TRANS/WP.29/2004/50  
11 August 2004

PROPOSAL FOR DRAFT SUPPLEMENT 25 TO THE 03 SERIES  
OF AMENDMENTS TO REGULATION No. 37

(Filament lamps)

Transmitted by the Working Party on Lighting and Light-Signalling (GRE)

Sheet H13/1

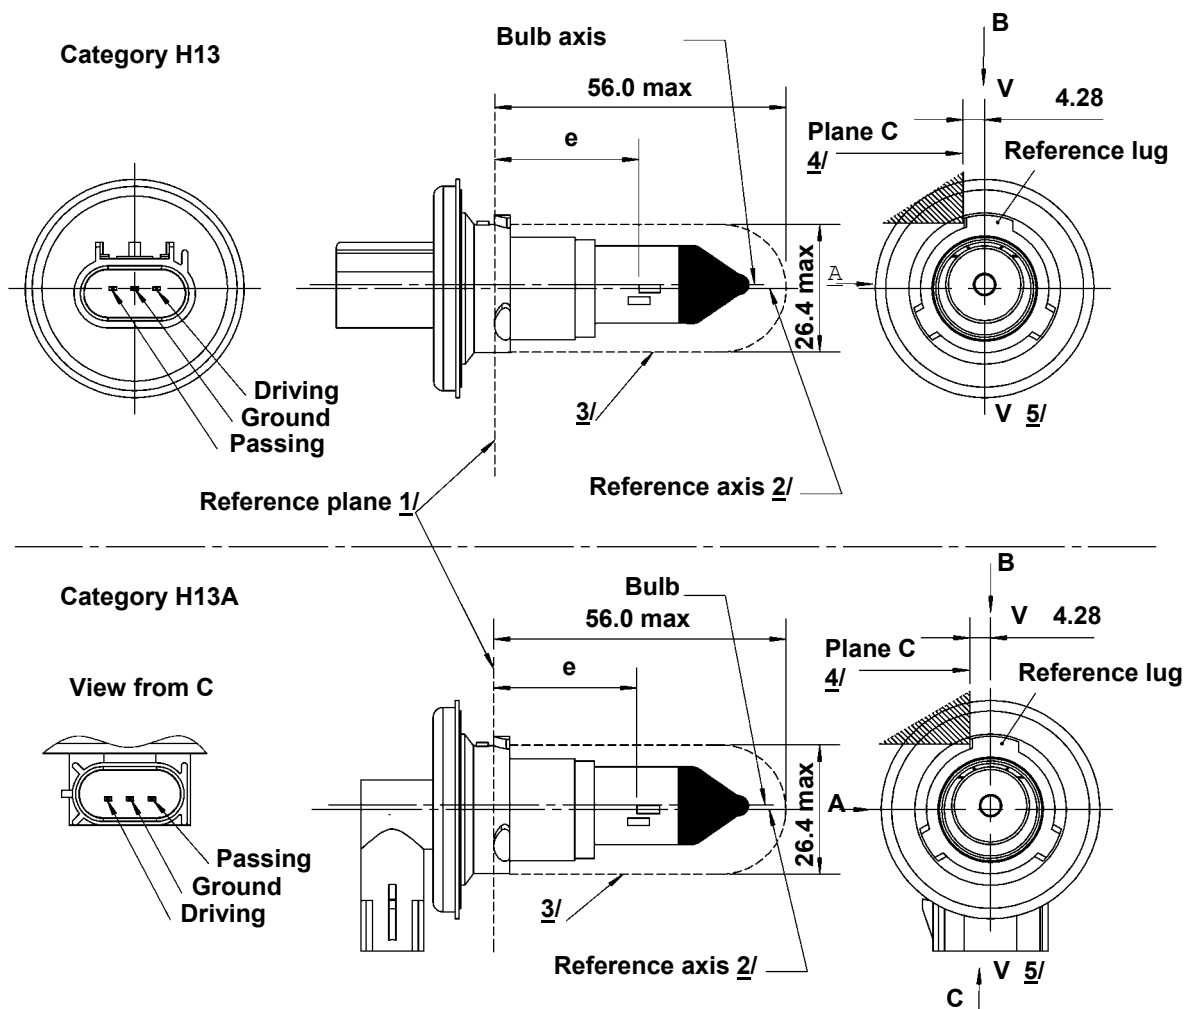
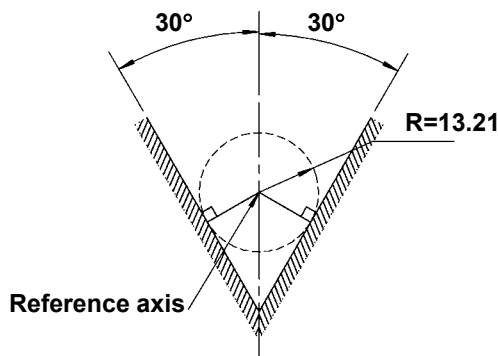
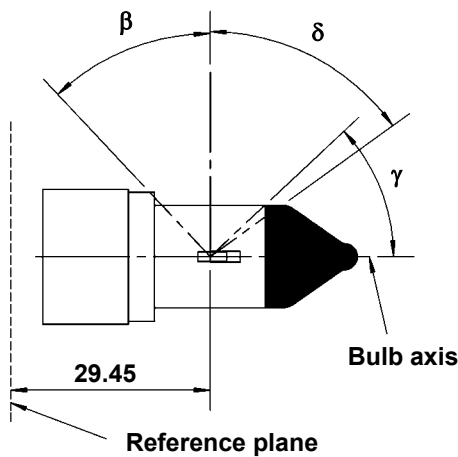
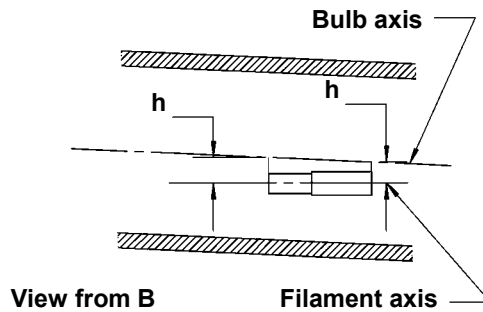
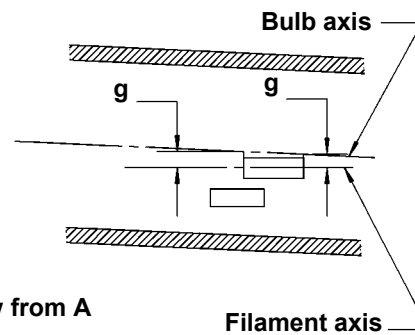
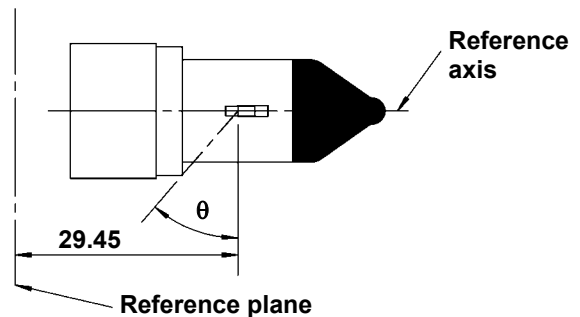
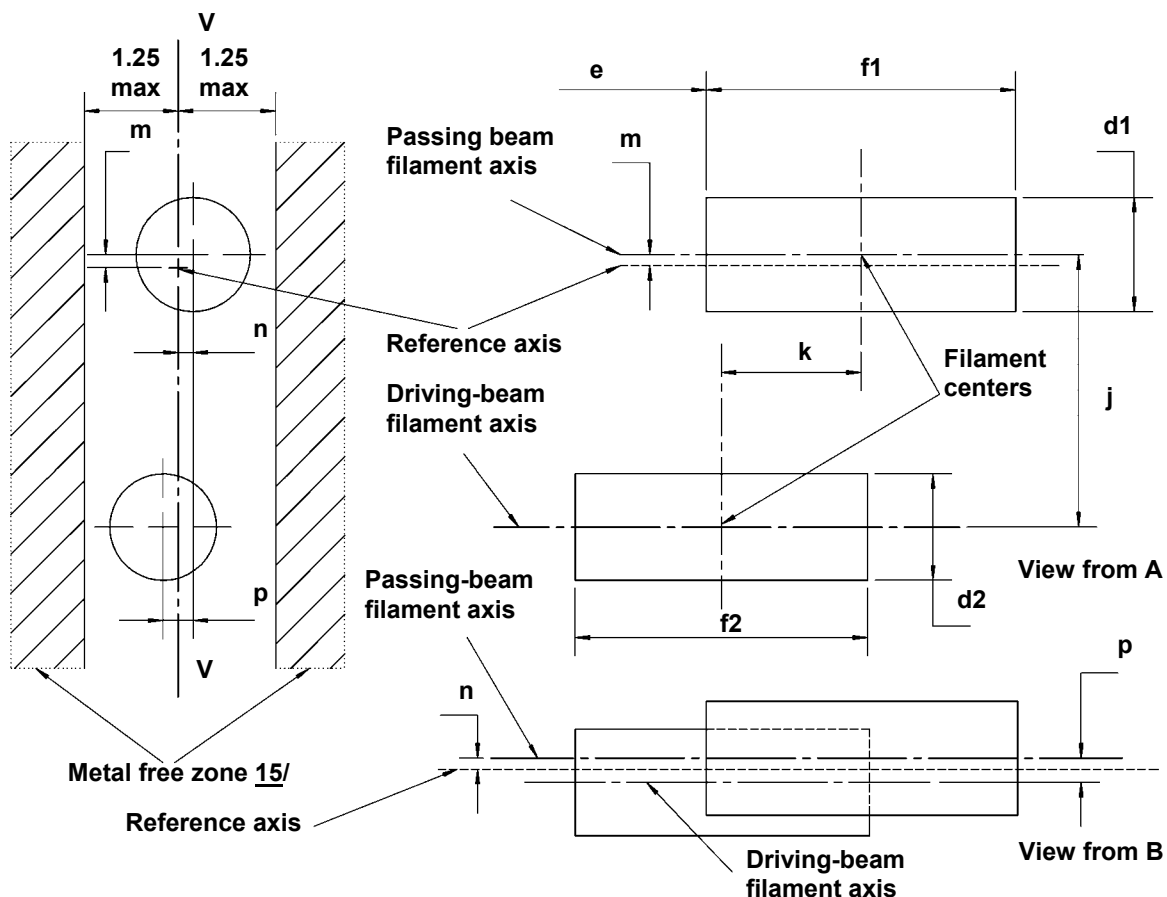
Sheets H13/1 to 4, replace by new sheets H13/1 to 4; (see next pages).

**CATEGORY P13W**

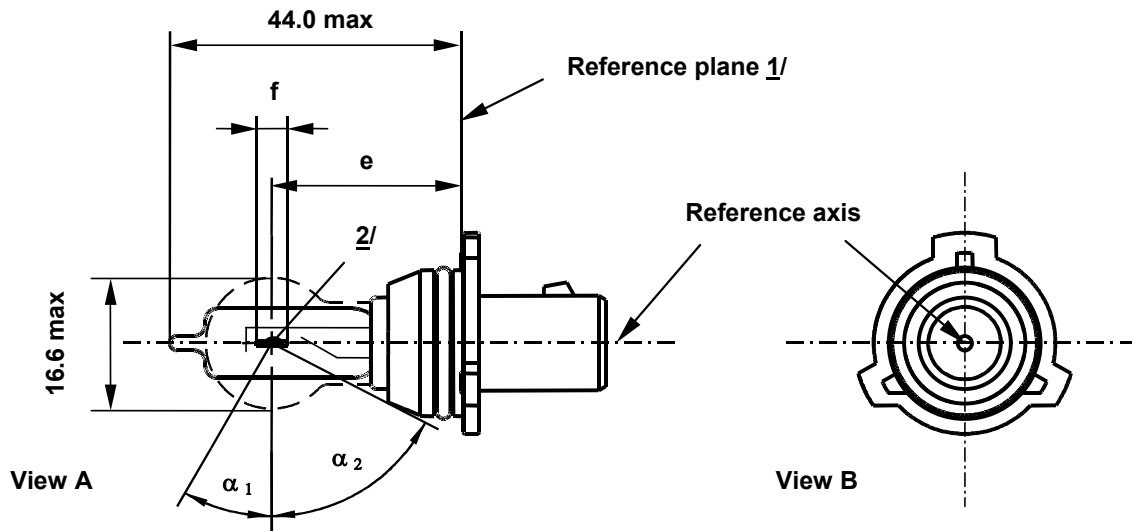
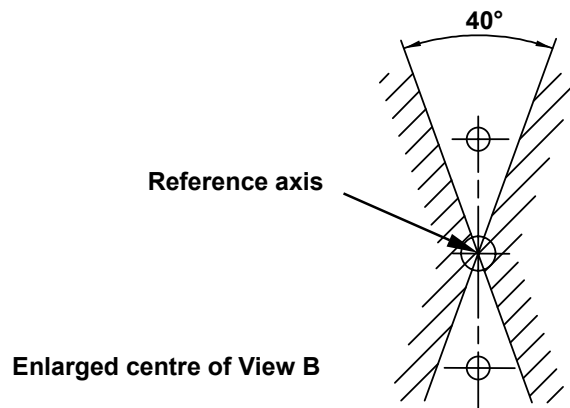
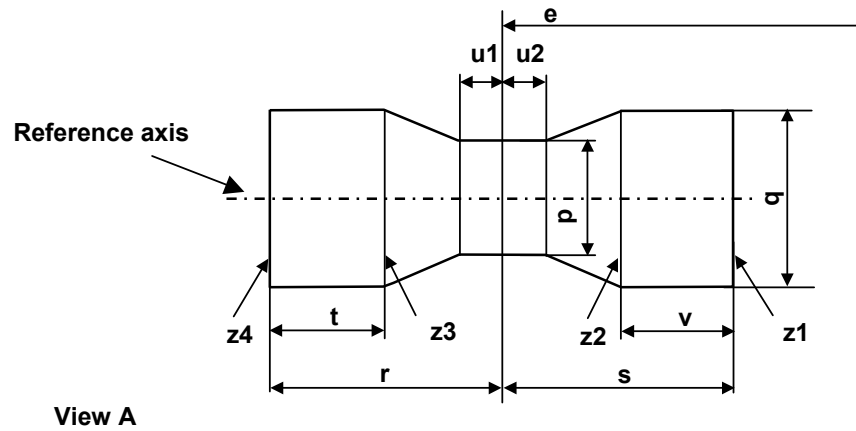
Insert new sheets P13W/1 to 3 (between sheet HS5/4 and sheet P19W/1 as indicated in the "List of sheets" above), to read: (see next pages).
